Official Transcript of Proceedings
NUCLEAR REGULATORY COMMISSION

Title: Advisory Committee on Reactor Safeguards
 U.S. EPR Subcommittee

Date: Tuesday, February 21, 2012

U.S. EPR SUBCOMMITTEE

Evolution of U.S. EPR Nuclear Island SSI Model

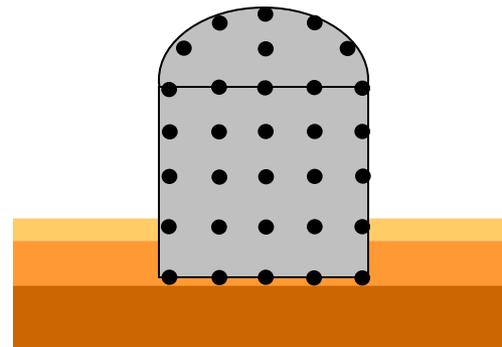
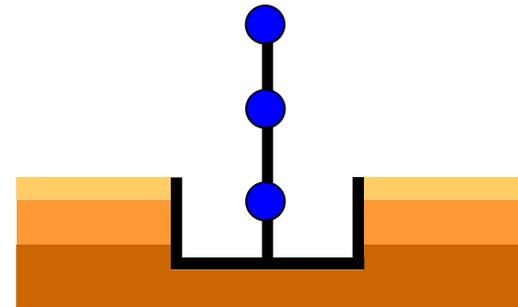
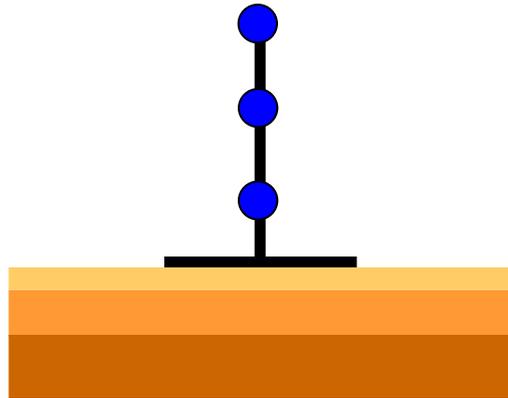
6 CHAIR POWERS: I am really interested in,
7 I have got a real structure. I calculate how it is
8 going to respond to a loading. How do I know that the
9 model is right, gives me a good answer?

20 CHAIR POWERS: So, how do we know it is
21 correct, that it gives us an answer that is useful?

16 MEMBER SKILLMAN: Let me build on Dr.
17 Powers' question, please. Is the model that you are
18 using peer-reviewed? Are other people who are in this
19 business using, if you will, the same or similar
20 model, the same or similar technology? So that, if
21 peers were to get together, one would say, using this
22 complicated model versus this other complicated model,
23 for all intents and purposes, they are predicting the
24 frequencies, the accelerations that are similar,
25 without those parties revealing, if you will, their

1 MEMBER SKILLMAN: My comment is not to
2 suggest an inadequacy. It is to dig into what Dr.
3 Powers is asking. How do you know the results are
4 ones that appropriately and accurately predict motions
5 and accelerations?

12 But in terms of the structure itself, as Todd alluded
13 to earlier, we have gone from simple stick models to
14 more complicated finite element models. We show that
15 we see certain trends. As you get more sophisticated,
16 the response, global responses remain essentially the
17 same, but you get additional detail.

7 MR. WONG: My confidence would be, going
8 back to this slide, when we go from a simple stick
9 model to the finite element model, there will be
10 similarities between the two. The overall global
11 response of the structure should be evidence in both
12 models. And we do see that in terms of the specific
13 details when you go to the finer model. When you go
14 from the very specific details, the only check that
15 you could rely on would be breaking it down to more
16 simpler models to see if --

5 And as I stated earlier, you do get
6 certain bounds that the more complicated model will
7 still have to comply with. So, really, the difference
8 between going from the stick to the finite element
9 model is we are trying to capture a little bit more
10 detail to capture the high-frequency response. But
11 the overall global responses remain the same. So,
12 that gives us confidence in our larger, more
13 complicated model, that we have captured the essence
14 of the destructive behavior.
